PIC18F2220/2320/4220/4320 Rev. B3 Silicon/Data Sheet Errata

The PIC18F2220/2320/4220/4320 Rev. B3 parts you have received conform functionally to the Device Data Sheet (DS39599C), except for the anomalies described below.

FIGURE 12-3: EXTERNAL COMPONENTS FOR THE TIMER1 LP OSCILLATOR

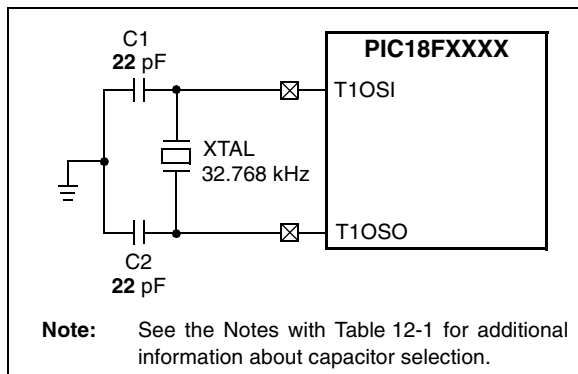
In **Section 12.2 “Timer1 Oscillator”**, capacitor values for C1 and C2 were incorrectly specified in Figure 12-3 and Table 12-1. The correct values are shown in bold:

FIGURE 16-1: SIMPLIFIED BLOCK DIAGRAM OF THE ENHANCED PWM MODULE

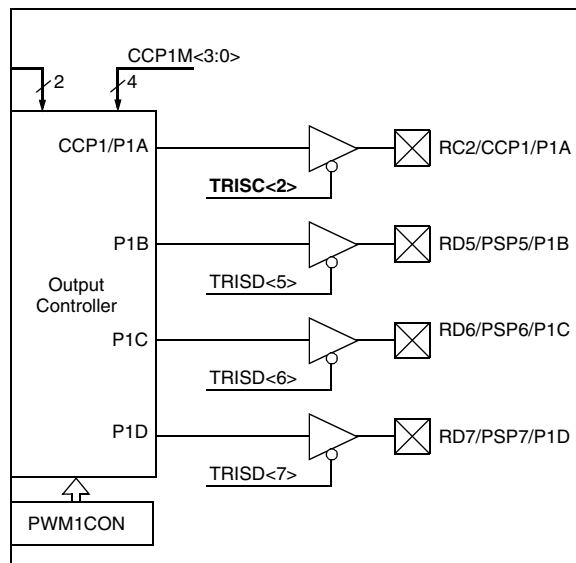
In **Section 16.4 “Enhanced PWM Mode”**, the incorrect TRIS bit (TRISD<4>) is specified in Figure 16-1 for RC2/CCP1/P1A. The correct bit is TRISC<2>. The correction is shown in bold text (only the affected area of the block diagram is shown to conserve space).
